Williamson Manufacturing product news.

The time has come to replace the 100 series injection mould tools. The current tools have been producing parts for over 20 years. Whilst we re-tooled we have taken the opportunity to add some new & improved features:

OLD 100 SERIES PUMP HEAD

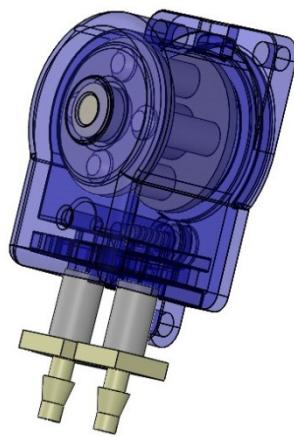
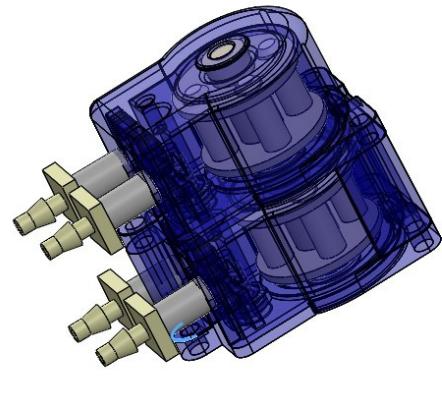
- **NEW TUBE GRIPS RETAINED IN COVER GIVING EASIER FITMENT OF LONG OR CONTINUOUS TUBE.**
- **PUMP BASE PLATE RETAINED WITH SINGLE SCREW ENABLING EASIER DISASSEMBLY & REASSEMBLY.**
- **3RD FIXING AVAILABLE STABALISING THE ASSEMBLY ESPECIALLY WITH A STACKED PUMP.**
- **SPACERS SUPPLIED WITH STACKED UNITS FOR BETTER STABILITY & ASTHETICS.**

The new 100 series mounts on the same fixing centres and is the same width as the old 100 series. The only change is the old pump head mounted using M3 x 25 screws the replacement uses m3 x 6. It also has the same rotor arrangement for fitting to 3mm D and 4 mm D shafts and will fit all the existing brackets and motors.
